## **Ford Galaxy with automatic air conditioning**

### **Model year up to 01.02.1996**

#### **Poor heating performance**

Fig. 1

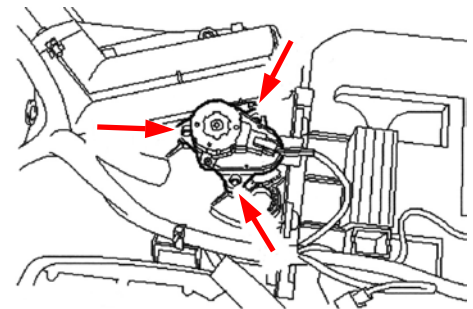
- Remove the safety cover from the servomotor.
- Remove the screws from the servomotor and take the motor out (see Fig. 1).
- Now remove 1.5 mm from the left-hand stop (see Fig. 2).
- Refit the servomotor and fix in place using the screws. Make sure that the tothing is seated correctly (see Fig.3).
- Refit the safety cover.
- Check the function and heating performance of the system.

Fig. 2

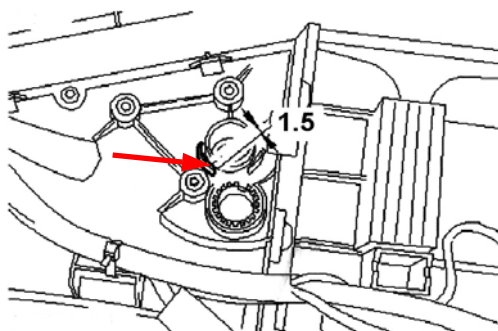
If there are complaints about the above-mentioned fault, a flap in the heating housing not closing completely could be the cause. To eliminate this fault, the stop on the servomotor for the temperature flap must be shortened by 1.5 mm. To do this proceed as follows:
